Subject: Zion Station Units 1 and 2
Zion Probabilistic Safety Study
NRC Docket Nos. 50-295 and 50-304

Summary of ACRS Review Questions and Comments
on the Zion Probabilistic Safety Study (PSS)

FIGURE 1. TYPICAL FRAGILITY CURVE

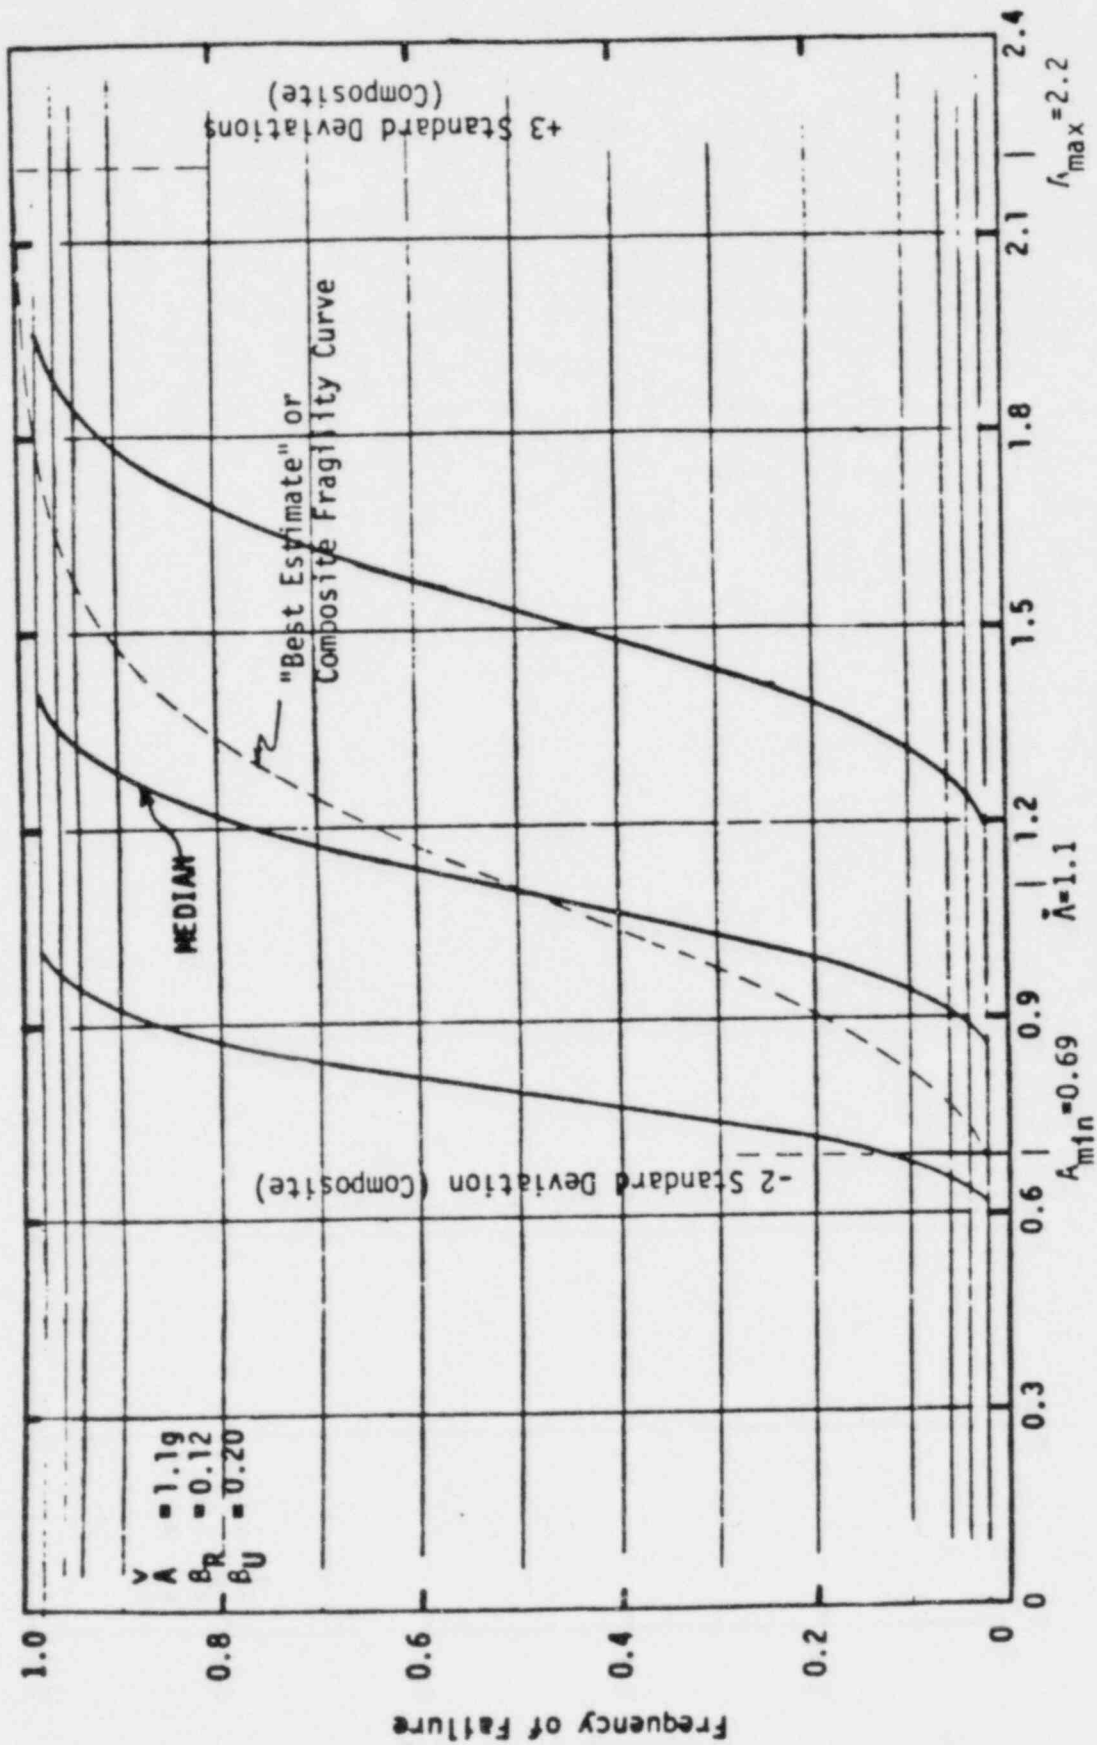
- The estimate of the mean frequency of core melt due to seismic events appears reasonable (assuming proper resolution of the questions that have been raised). However, changes to the tails of the probability density function for core melt are expected to be substantial.

The lognormal distribution can be expected to provide reliable results through the majority of the fragility curve so long as one is not primarily interested in the tails of the distribution below 1 to 2 percent. As discussed in the report developed by SMA for seismically induced failures in support of the Zion Probabilistic Safety Study, use of the lognormal distribution for estimating very low failure fractions is considered to be conservative. The degree of conservatism introduced into the probability of release is dependent not only on the conservatism in the fragility description but also on the seismic hazard description at the low seismic levels. However, if the occurrence of the seismic hazard for low input levels is large enough, it is apparent that very low level earthquakes can govern the seismic induced release.

This is considered unrealistic for engineered structures and equipment found in nuclear power plants. For low level earthquakes, it is expected that below some threshold, there is virtually no chance of failure due to seismic excitation. Material strength data, for instance, normally does not fall to very low values compared to the median value but instead normally exhibits some lower bound. Other variables such as damping also indicate both lower and upper bounds which are not zero or infinite damping. Extensive studies have been conducted to develop response spectra from available earthquake records and while dispersion exists about the median values, spectra with essentially zero or infinite response do not occur. For these, as well as other variables contributing to the seismic fragility of a given structure or component, it is apparent that some lower and upper bound cutoffs on the tails of the dispersion exist. Since the overall fragility curves are based on a combination of these variables, it is expected a threshold exists below

It is therefore recommended that for the Zion PSS that where a significant contribution to risk arises from very low level earthquakes, that the above truncation be applied in order to eliminate any excess conservatism introduced by the use of the lognormal distribution at very low frequencies of failure. An example is shown in Figure 1 for a typical fragility curve. In this example, the median effective peak ground acceleration for failure is approximately 1.1g with a random lognormal standard deviation (β_R) of 0.12 and lognormal standard deviation associated with uncertainty (β_R) of 0.20. The "best estimate" or composite standard deviation (β_C) is therefore approximately 0.23. Using the approach discussed above, the cutoff ground acceleration associated with minus two lognormal standard deviations is approximately 0.69g and intersects the composite fragility curve at a frequency of failure of approximately 0.02. The upper bound cutoff at plus three standard deviations occurs at approximately 2.2g.

Figure 1.3.4.11-2. Event Tree 11b, Turbine Trip Due to Loss of Offsite Power (Buses 148 and 149 Failed)

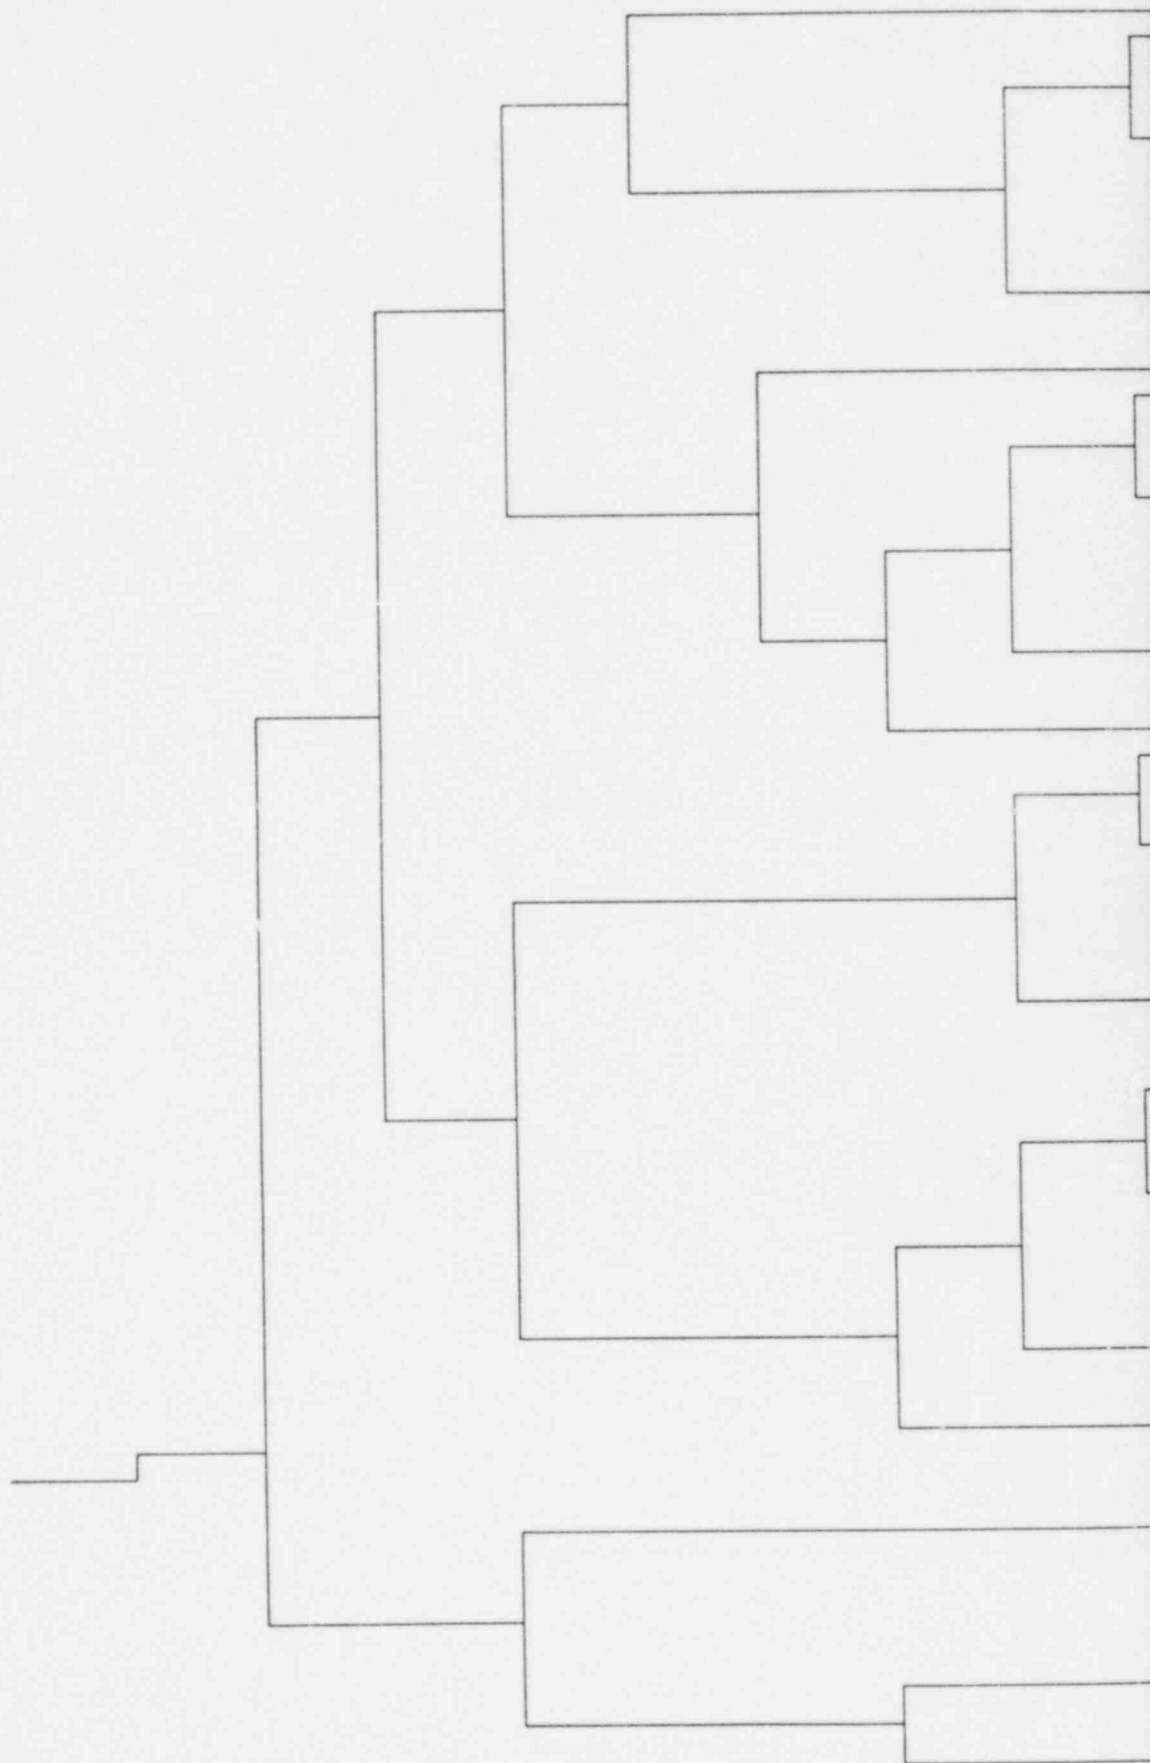
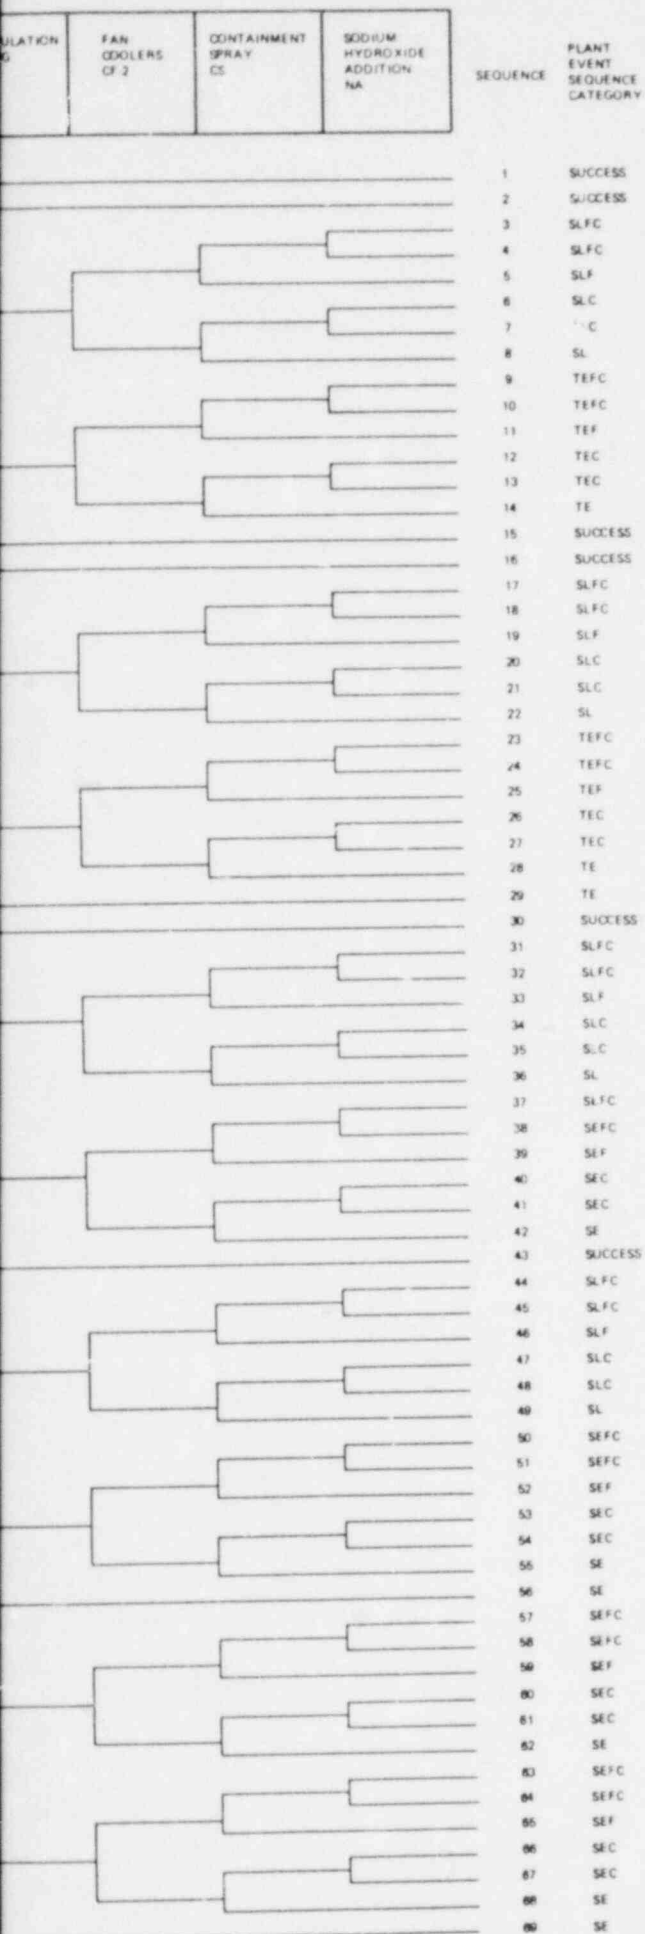
- (3) A Third accident sequence, Station Blackout due to a LOP transient, is a dominant contributor to risk. The calculation is or has been pursued by Buslik, Earls, and Kolb. The questions arising have to do with several factors, including the treatment of the increasing trend in the unavailability of the turbine-driven pump, the appropriateness of the LOP transient frequency prediction, and the onsite emergency power restoration assumptions. Depending on the way some of these are treated, the mean for this sequence could be approaching two orders of magnitude higher than the study predicts. This also deserves further investigation (JH, p. 7); as does the assumed quick recovery of offsite power as the grid margin is reduced. (PD, p. 5)

First of all, we wish to acknowledge that the reviewers called our attention to errors in the loss of offsite power event tree model. We have now revised that analysis and the changes are included as Attachment 2.

The new model is more complete in terms of tracking sequences involving recovery from all electric power states. Along with correction of non-conservative numerical and logic errors, we corrected the overly conservative assumption that a seal LOCA leads to melt. With the recovery of electric power, bleed and feed cooling with high pressure injection can lead to success. It should be noted that the corrections lead to no changes in release category frequencies or consequences. However the following changes in plant damage state mean frequencies do occur:
